UNITED STATES PATENT AND TRADEMARK OFFICE

APPLICATION NO.	FILING DATE	FIRST NAMED INVENTOR	ATTORNEY DOCKET NO.	CONFIRMATION NO.
10/697,757	10/30/2003	Frank A. Baiocchi	2-8-2-3	8761

Office Action Summary

DETAILED OFFICE ACTION

FIG. 2B

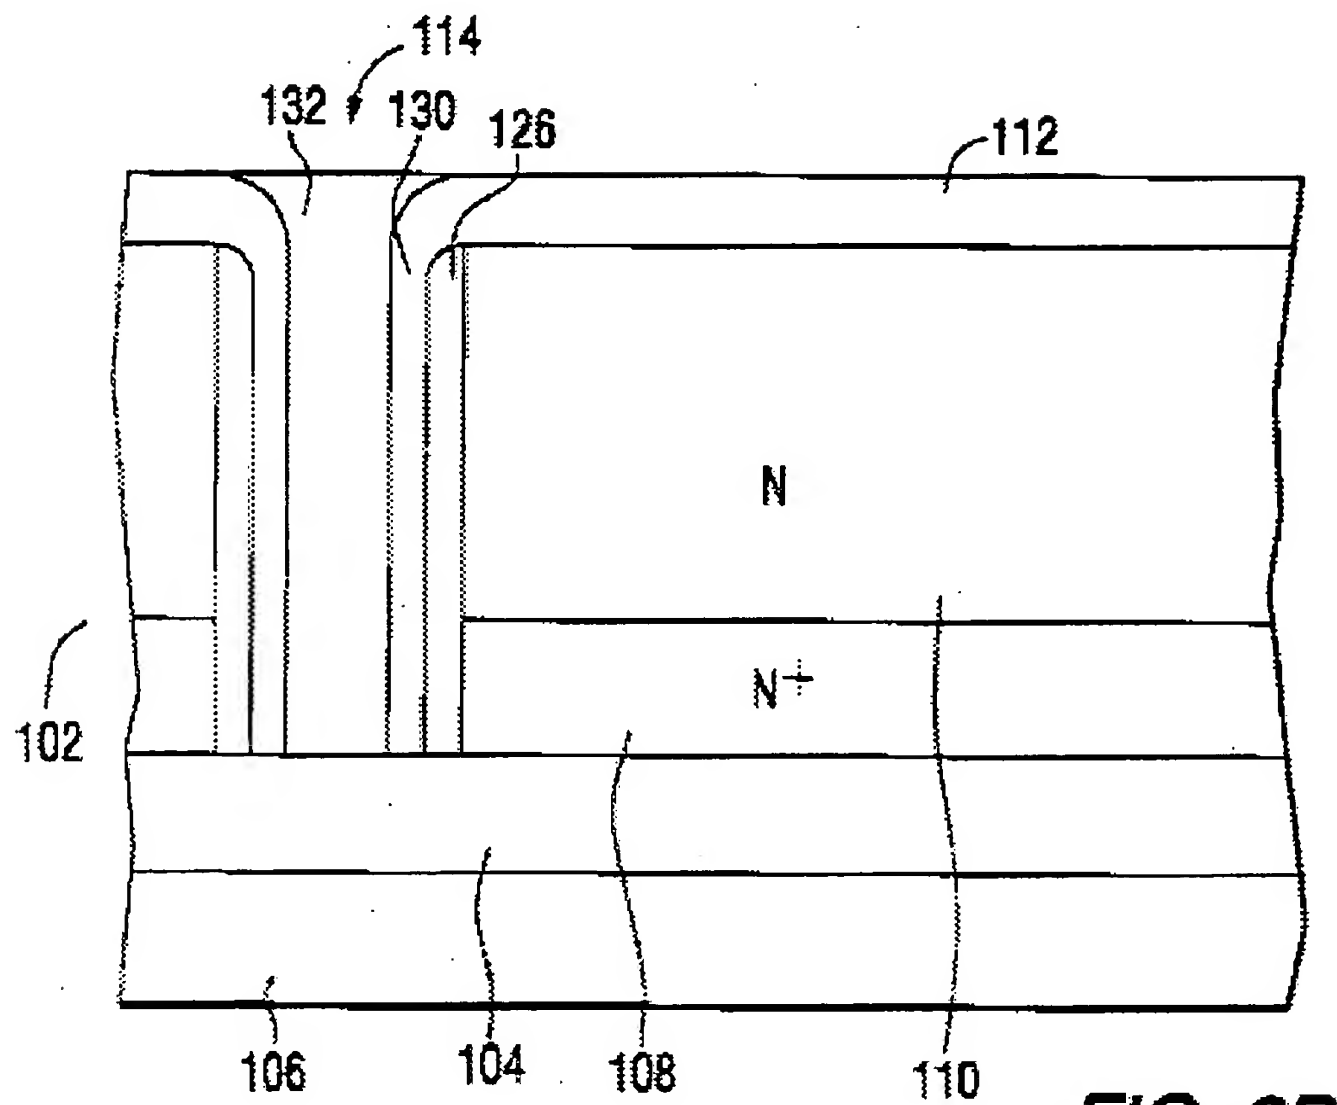
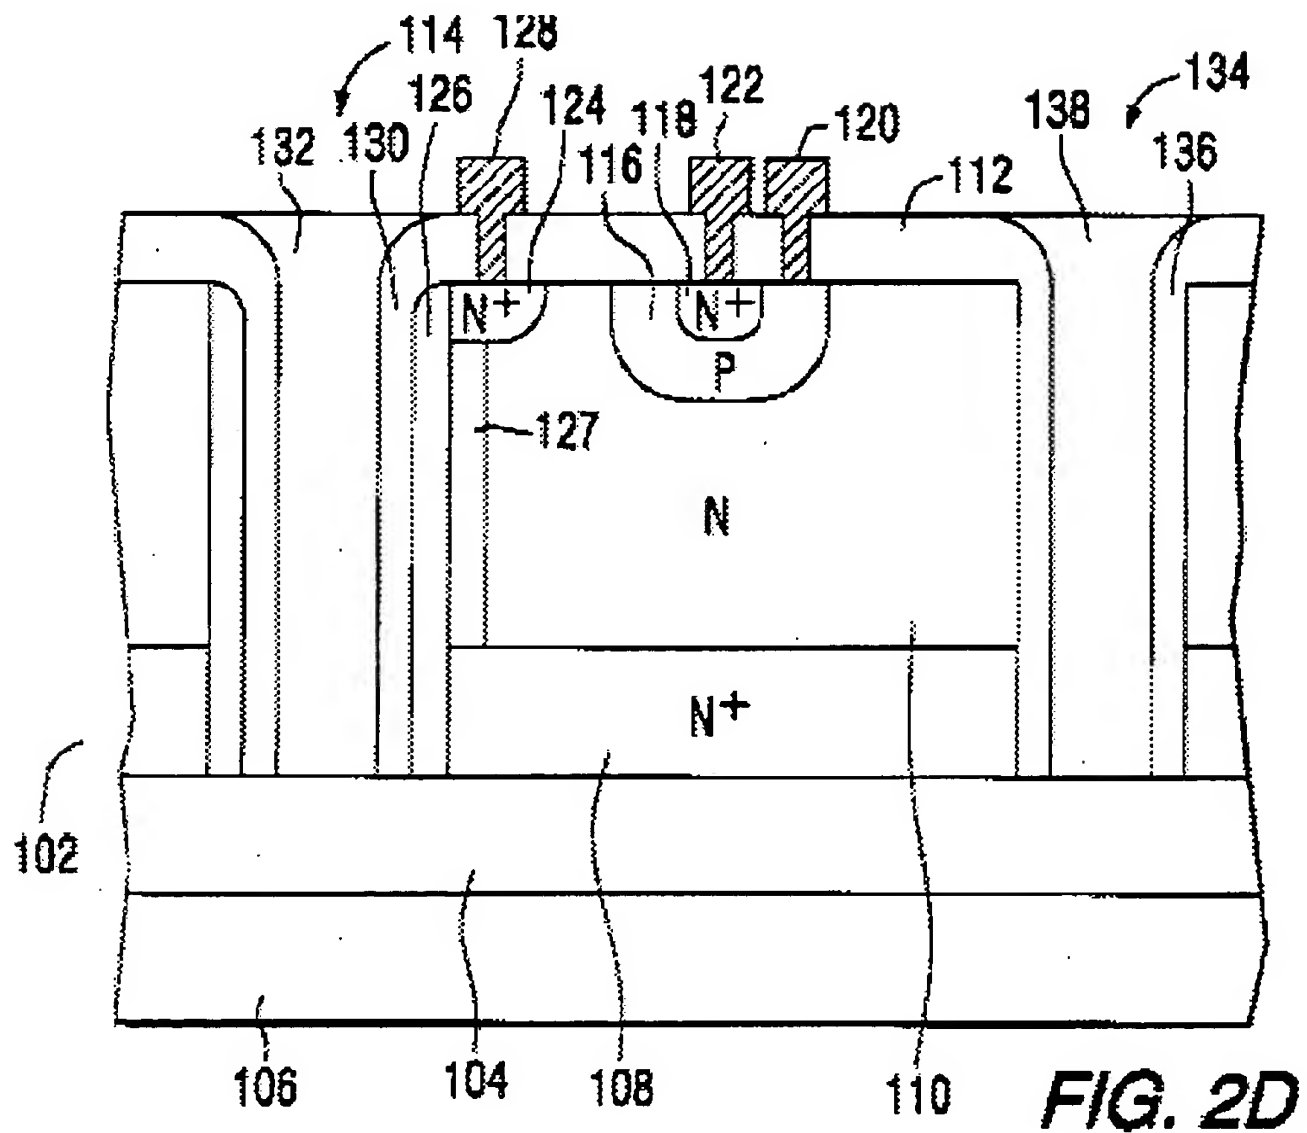
Woodberry (the abstract, fig 2B and 2D, column 3 lines 14-20,column 4 line 11) discloses a method of forming a semiconductor structure on a semiconductor wafer, the method comprising the steps of: forming an epitaxial layer on a least a portion of a semiconductor substrate of a first conductivity type; forming at least one trench through the epitaxial layer to at least partially expose the substrate, doping at least one or more sidewalls of the at least one trench with an impurity of a known concentration level so as to form a low-resistance electrical path between an upper surface of the epitaxial layer and the substrate, and substantially filling the at least one trench with a filler material.

Woodberry (the abstract, fig 2B and 2D, column 4 lines 1-3, trench 114) discloses a method of forming a semiconductor structure on a semiconductor wafer, wherein the step of forming the at least one trench comprises: forming an insulating layer on at least a portion of the epitaxial layer, forming at least one opening in the insulating layer corresponding to the at least trench, and etching through the epitaxial layer to at least partially expose the substrate.

Woodberry (the abstract, fig 2B and 2D, column 4 lines 1-2) discloses a method of forming a semiconductor structure comprising the step of forming at least one insulating Layer (fig 2B, layer 112) on at least a portion of the epitaxial layer.

FIG. 1

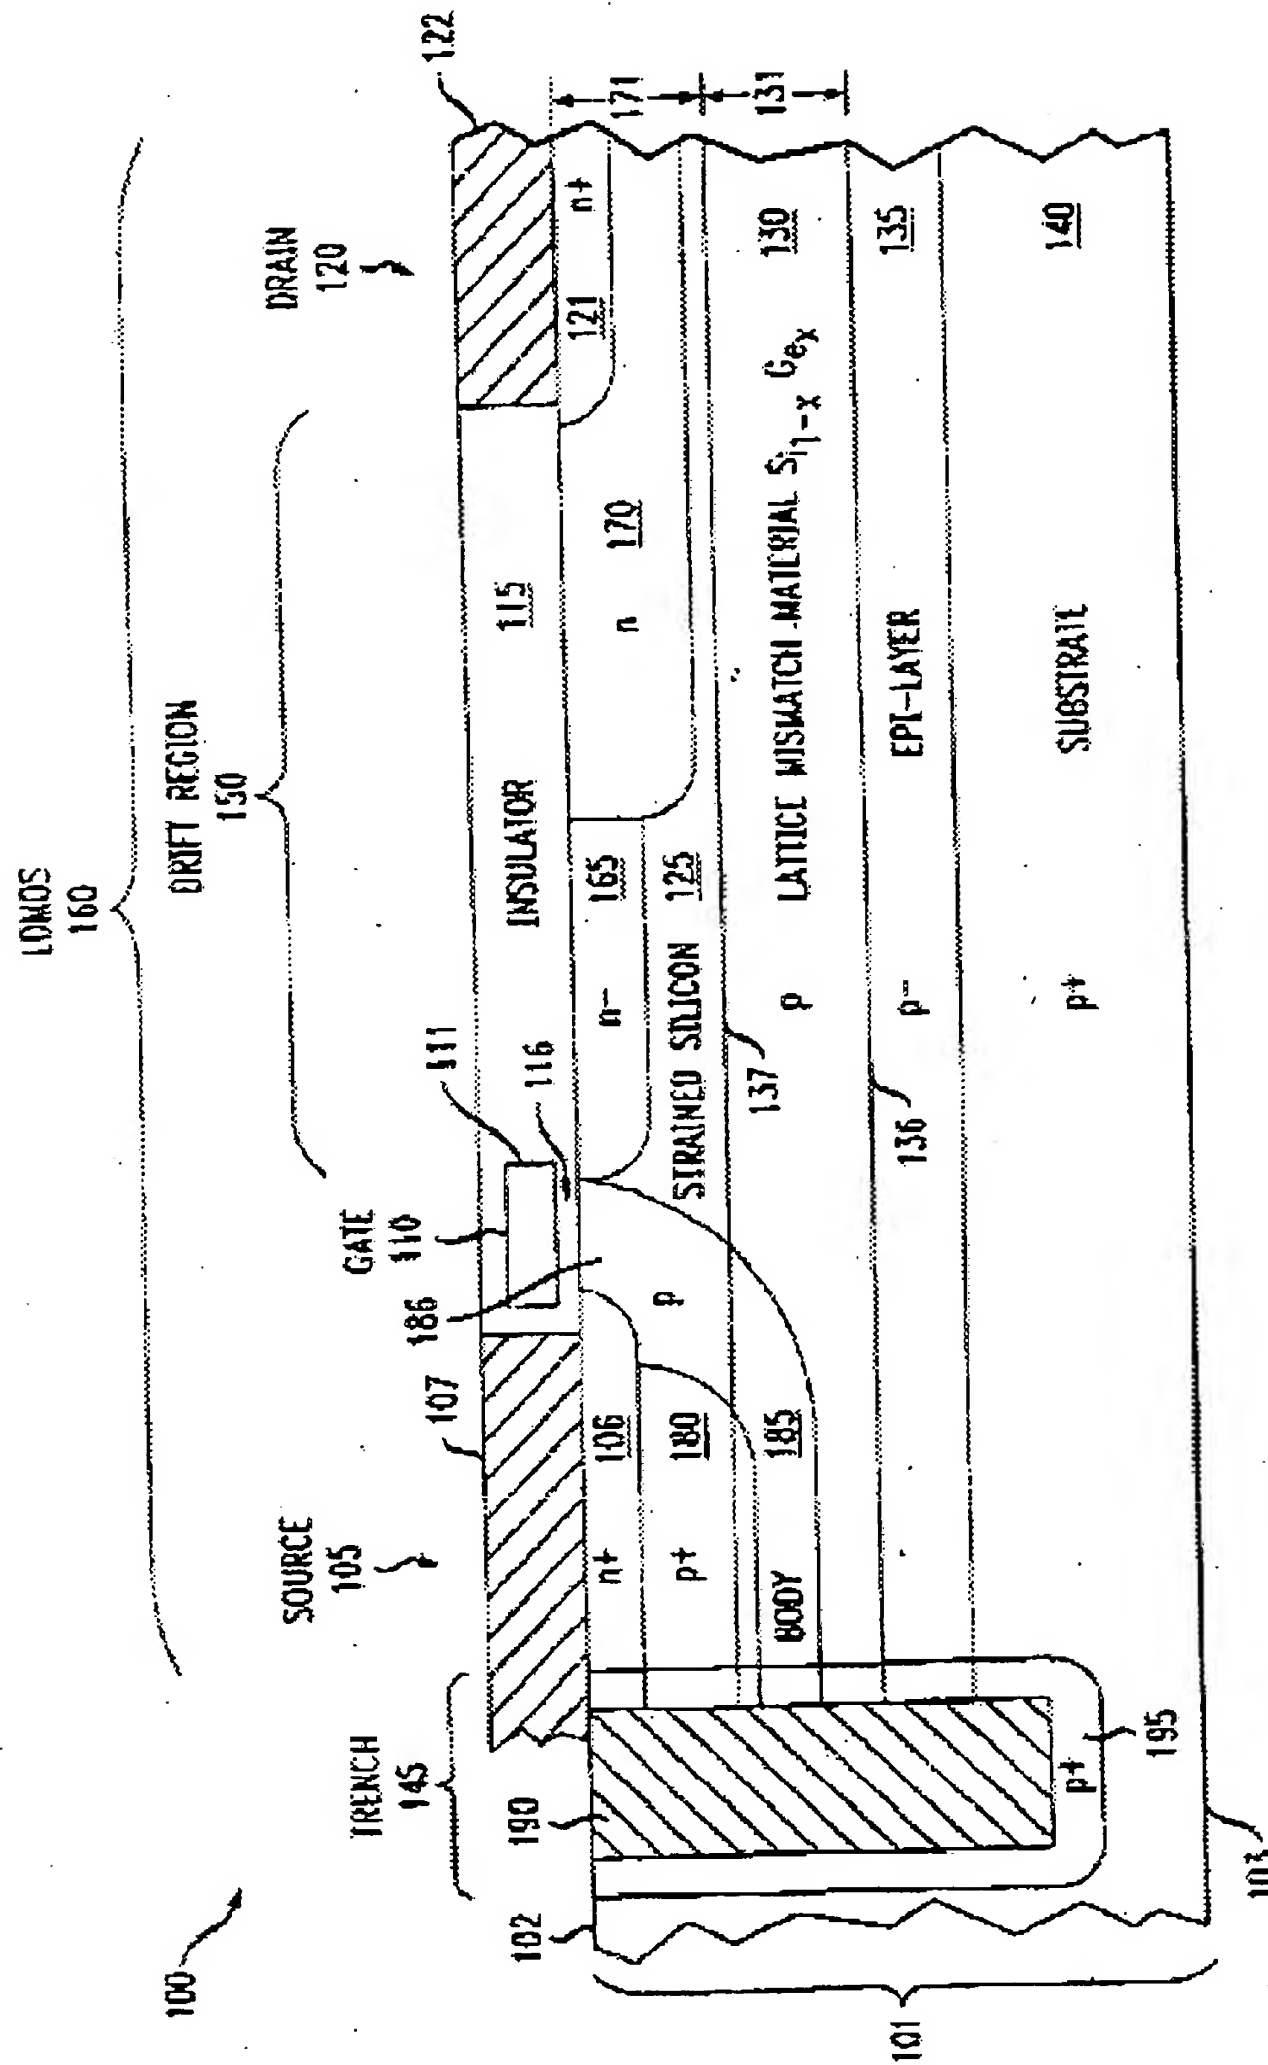
Hergenrother discloses (in the abstract, in fig 1) a method of making a semiconductor that has a doped connecting trench sidewalls and the active device is a MOS device that has the gate in the insulated layer with first and second source / drain region and with first source/ drain Region connected to a substrate with a trench.
